STAFF REPORT
COMMUNITY DEVELOPMENT DEPARTMENT

HEARING DATE: 4/12/2022
TO: Mayor & City Council
FROM: Alan Tiefenbach, Associate Planner
208-489-0573
SUBJECT: FP-2022-0006
Oakwind Estates No. 2
LOCATION: The site is located at 6180 W. McMillan Rd, in the SW ¼ of the SW ¼ of Section 28, Township 4N. Range 1W.

Final plat consisting of 70 single family lots, 1 common driveway and 9 common lots on 8.82 acres of land in the R-15 zoning district.

B. Final Plat (date: 2/3/2022)

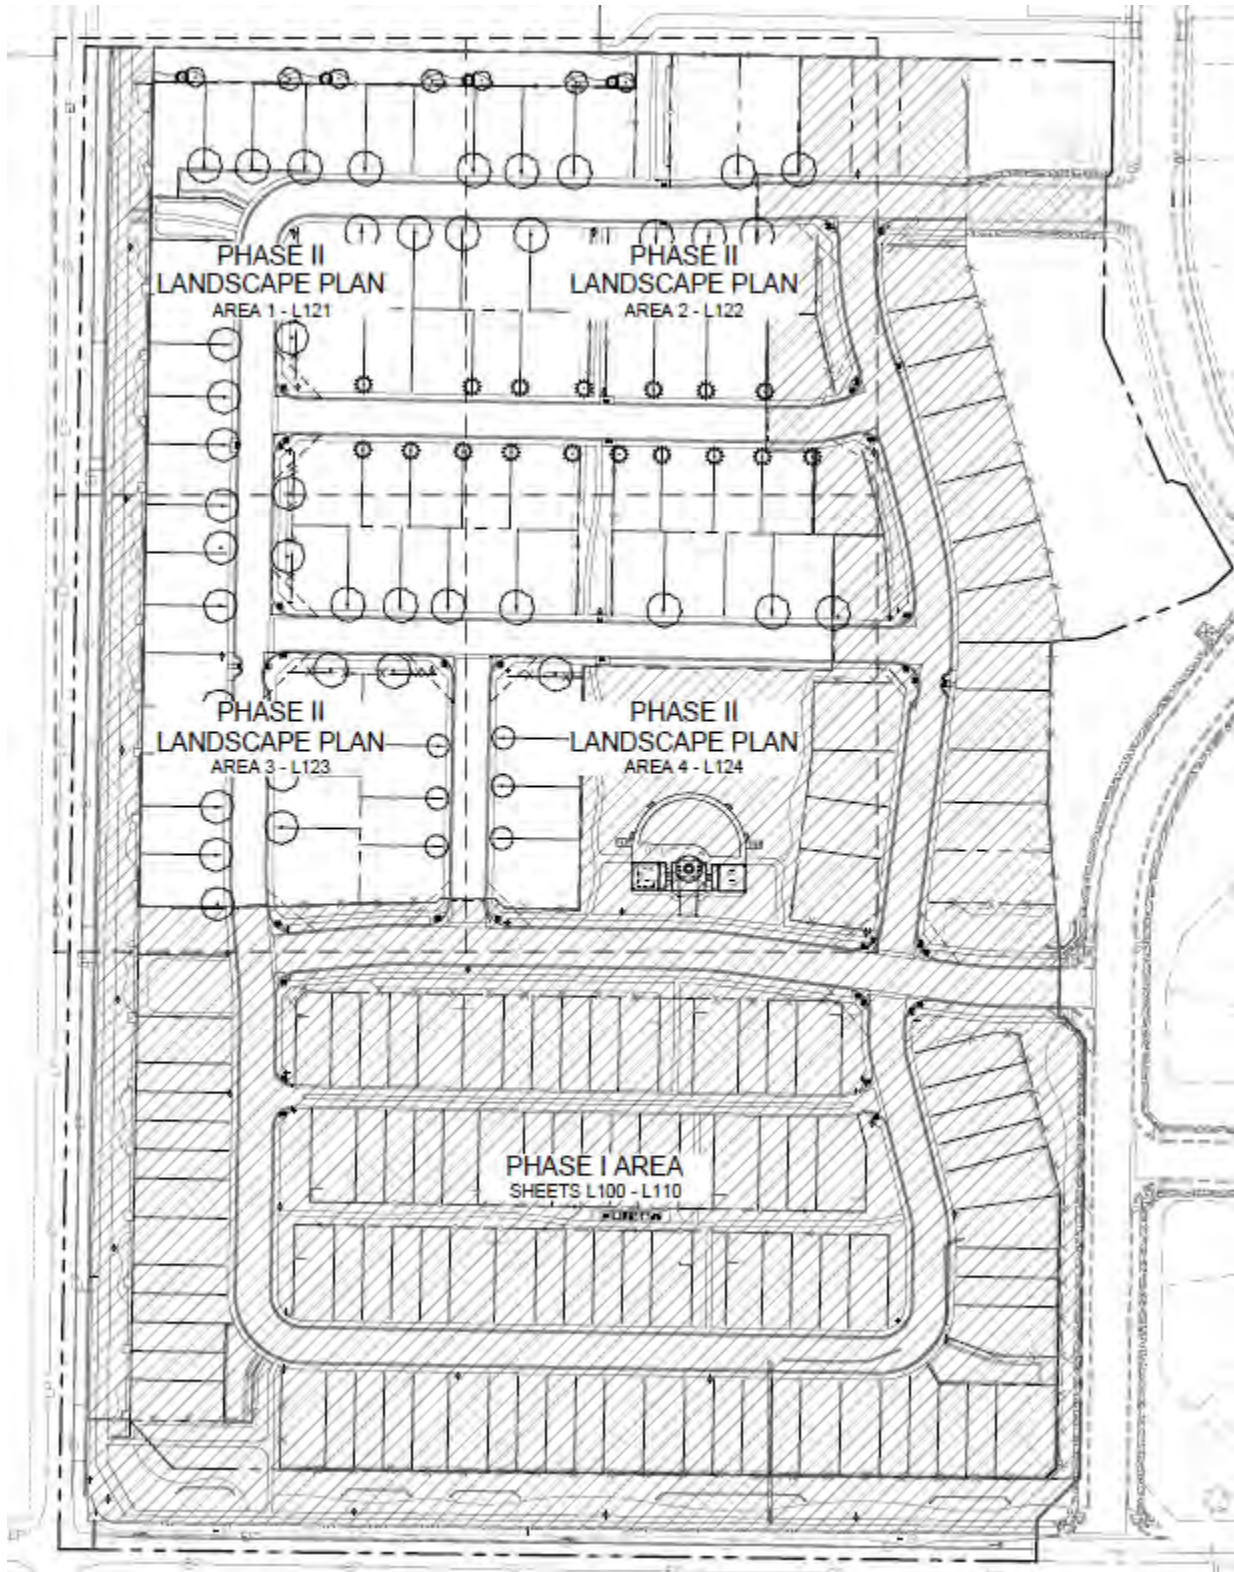
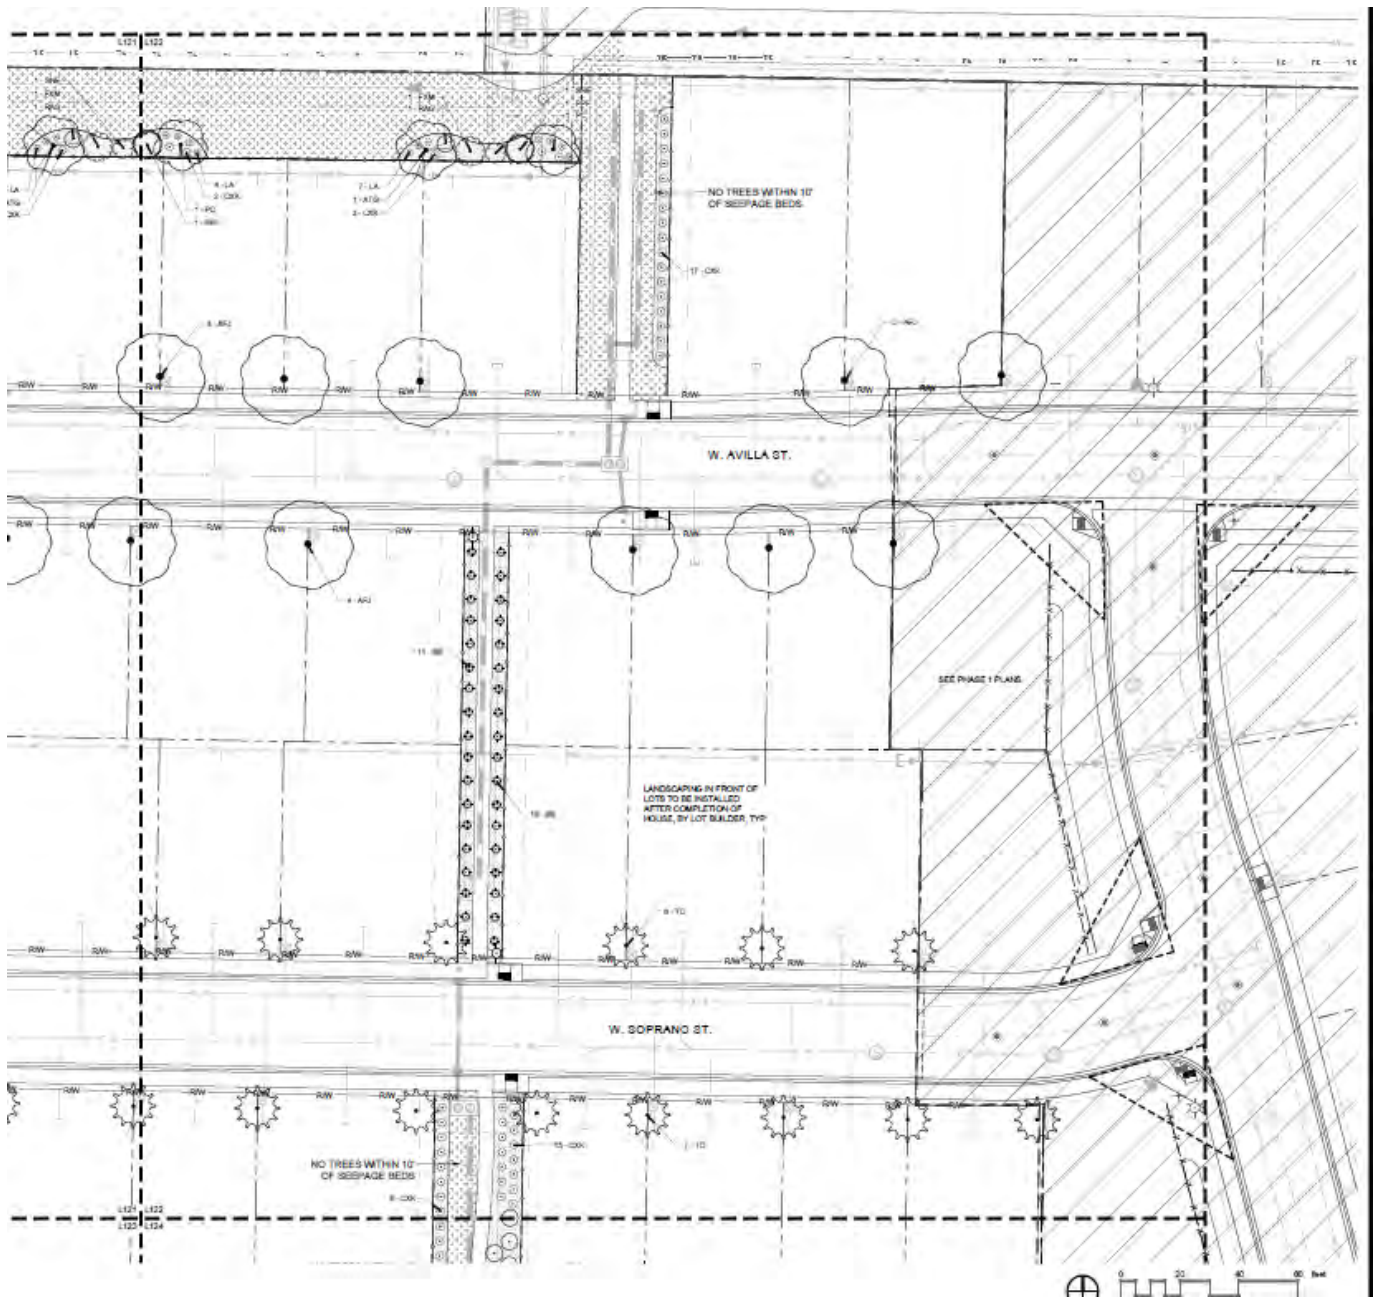
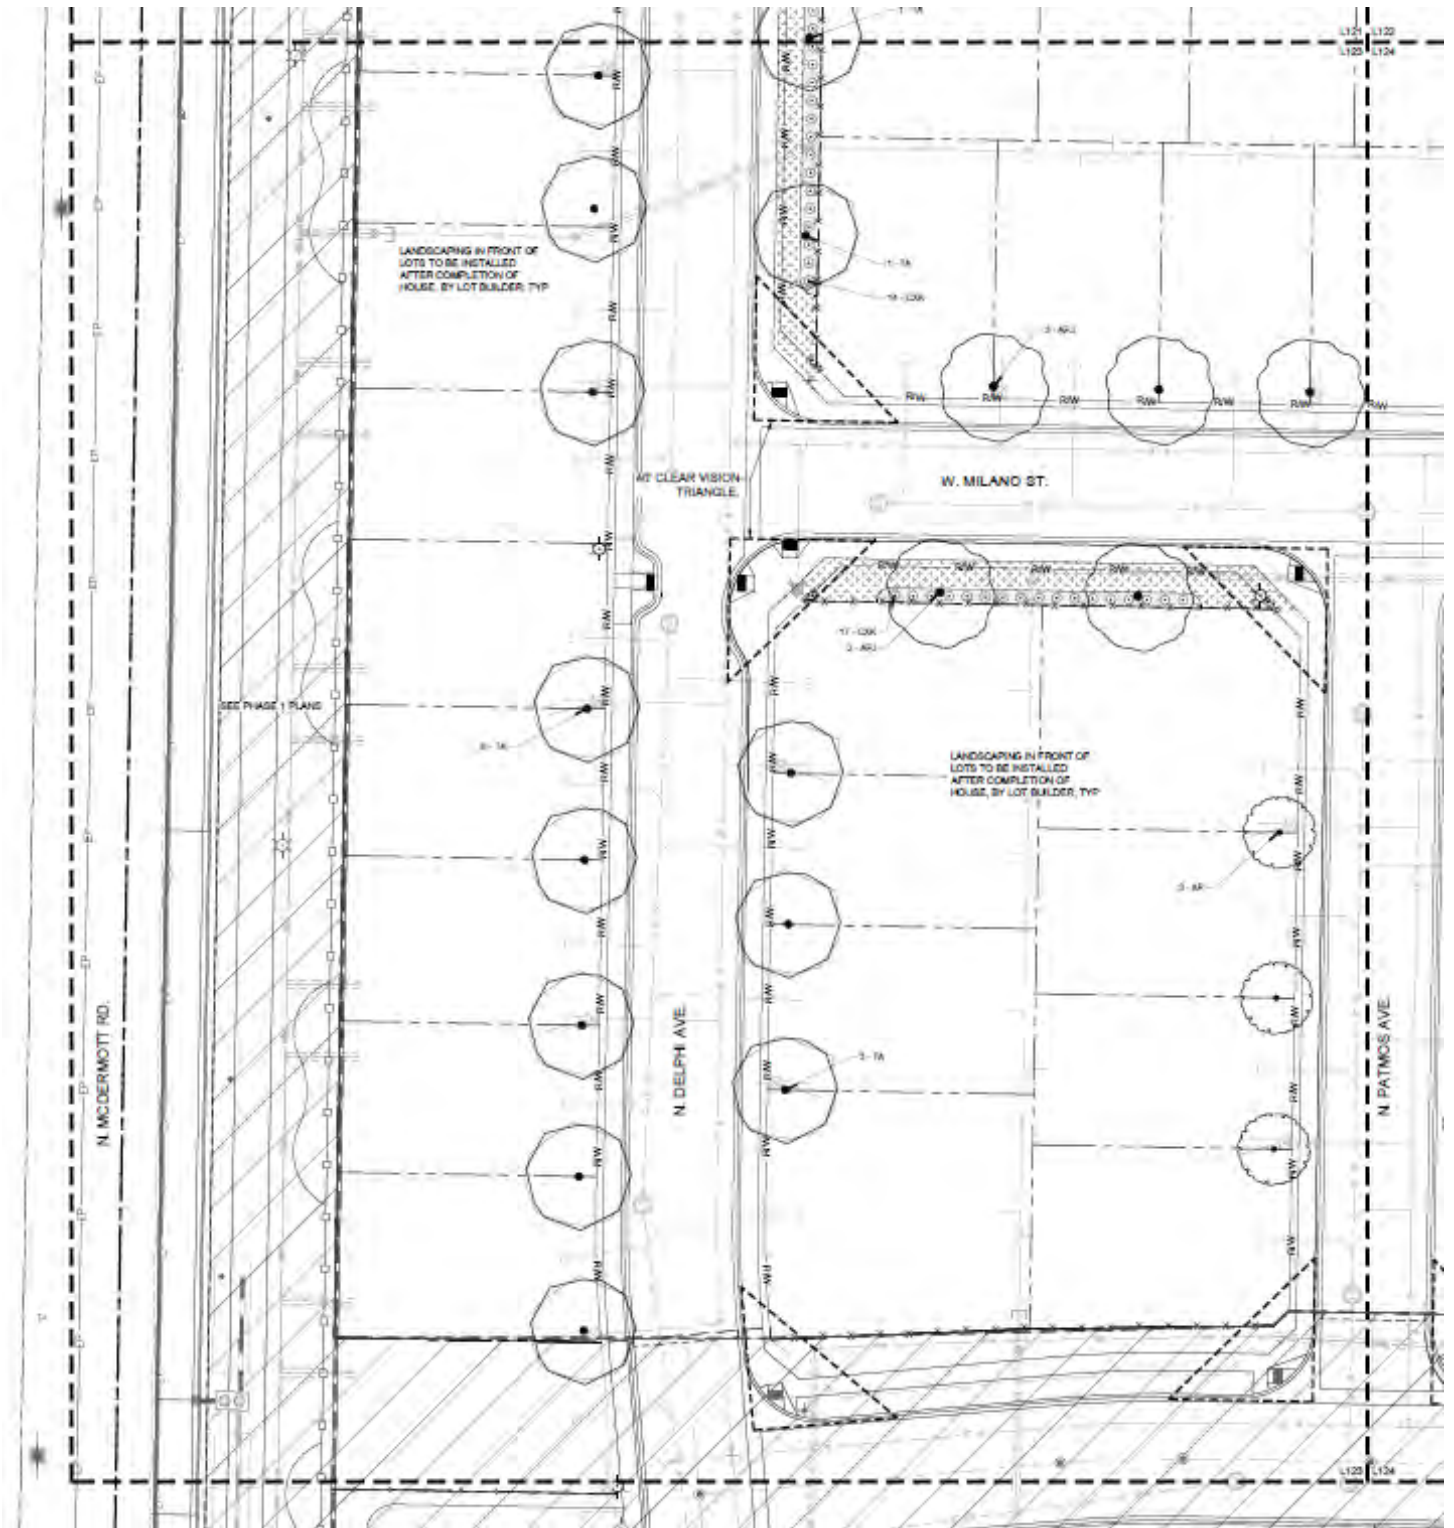
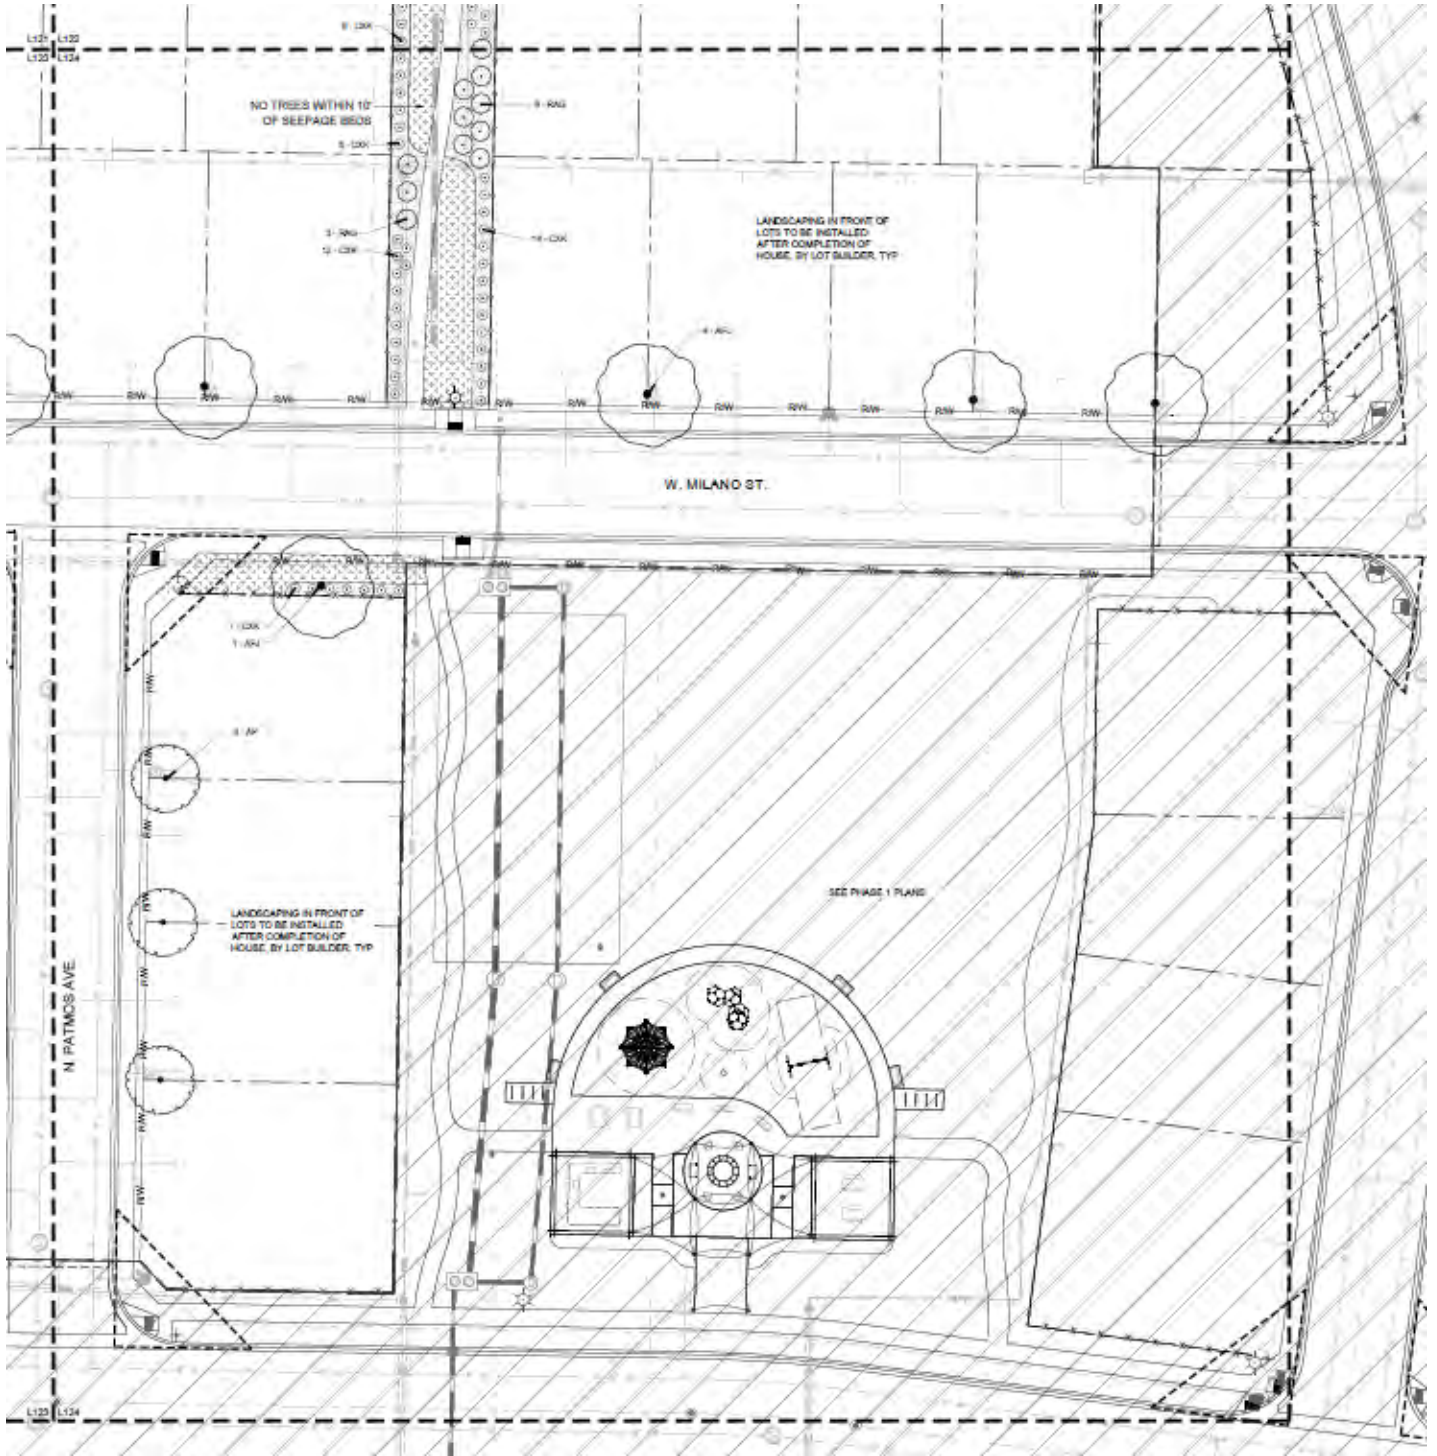
- a. Note 10, add Instrument Number.
 - b. Note 12, add Instrument Number.
4. The landscape plan, prepared by Stack Rock Group on 02/04/2022 is approved with the following revisions:

C. Landscape Plan (date: 02/4/2022)

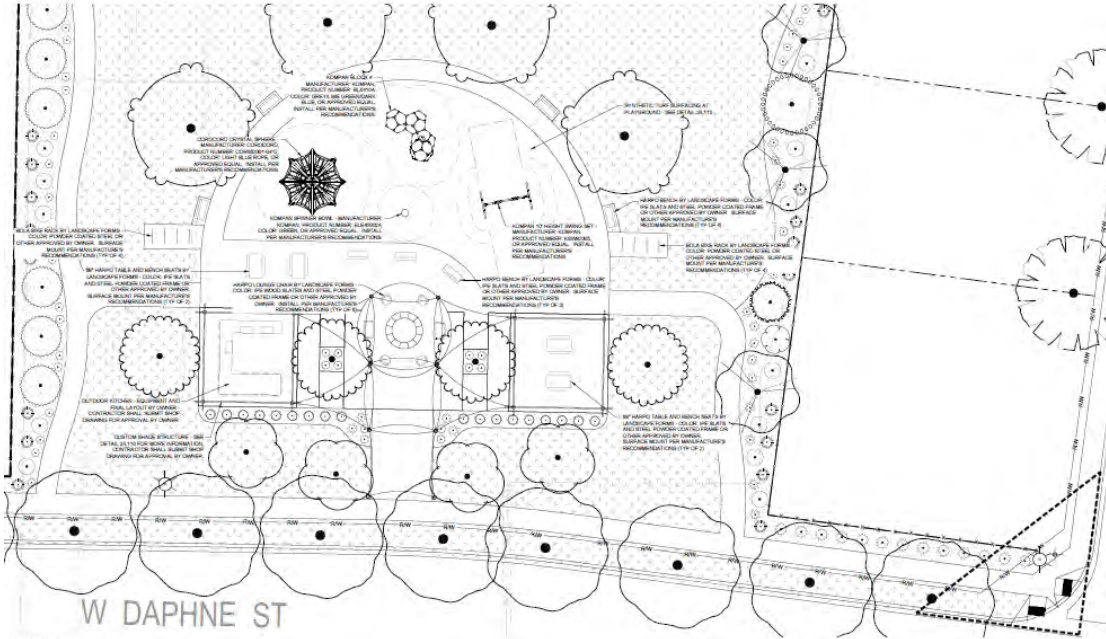
UDC 11-3B-12 requires all pathways to be landscaped with a strip a minimum of five (5) feet wide along each side of the pathway, with a mix of trees, shrubs, lawn, and/or other vegetative ground cover and a minimum of one (1) tree per one hundred (100) linear feet of pathway. There are pathway lots in which this requirement is not met. This includes Lot 8 Block 6, Lot 7 Block 7, and Lots 6 and

18 Block 8. The applicant will either need to revise the landscape plan to meet the regulations, or apply for alternative compliance prior to signature on the final plat.

- a. All pathway lots (Lot 8 Block 6, Lot 7 Block 7, Lot 6 and 18 Block 8) shall be planted in accordance with UDC 11-3B-12 including a landscape strip a minimum of five (5) feet wide along each side of the pathway and one (1) tree per one hundred (100) linear feet of pathway, or the applicant shall apply for alternative compliance prior to signature of the City Engineer on the final plat.
